Access Compliance Report

Public Rights-of-Way

Intersection ID: 48941	Main Street: PEPPERPIKE_WY	Cross Street: MORGAN_LEE_AV	Location: SW
ADA ID: 2B55D01A601A	Ramp Type: Perp	Initial Pass/Fail: Fail	Overall Compliance: No
Severity Score: 8.75			
Codes/Mitigation Info/Possible Solution		Field Measurements/Component Compliance

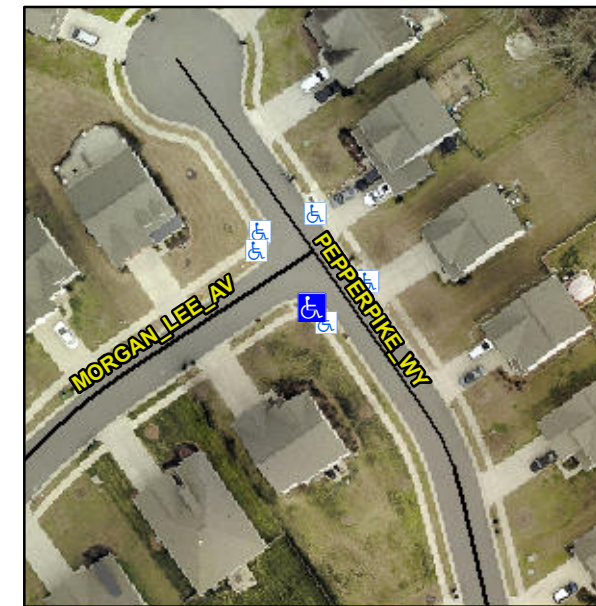
Not Found, R304.5.1

Compliance	Description	Data	Compliance	Description	Data
N/A	Ramp Length (in)	48.0	Yes	Ramp Slope (%)	5.1
No	Ramp Width (in)	47.5	Yes	Ramp XSlope (%)	1.0
N/A	Flare Type LT	N/A	N/A	Flare Type RT	N/A
N/A	Flare Slope LT (%)	N/A	N/A	Flare Slope RT (%)	N/A
N/A	Flare Traversable LT?	N/A	N/A	Flare Traversable RT?	N/A
N/A	Landing Length (in)	N/A	N/A	DWS Provided?	N/A
N/A	Landing Width (in)	N/A	N/A	DWS Contrast?	N/A
N/A	Landing Slope (%)	N/A	N/A	DWS Length (in)	N/A
N/A	Landing X Slope (%)	N/A	N/A	DWS Full Width?	N/A
N/A	Landing Curb? (Y/N)	N/A	N/A	DWS Offset (in)	N/A
N/A	Shared Landing?	N/A			
N/A	Gutter Ponding?	N/A	N/A	Gutter Slope (%)	N/A
N/A	Gutter Lip Ht (in)	N/A	N/A	Gutter X Slope (%)	N/A
N/A	Painted X Walk1?	No	N/A	Painted X Walk2?	N/A
	X Walk 1 Direction	To NW		X Walk 2 Direction	N/A
N/A	X Walk 1 Width (in)	N/A	N/A	X Walk 2 Width (in)	N/A
	X Walk 1 Slope (%)	4.2		X Walk 2 Slope (%)	N/A
	X Walk 1 X Slope (%)	0.2		X Walk 2 X Slope (%)	N/A

Remove & Replace Entire Ramp.
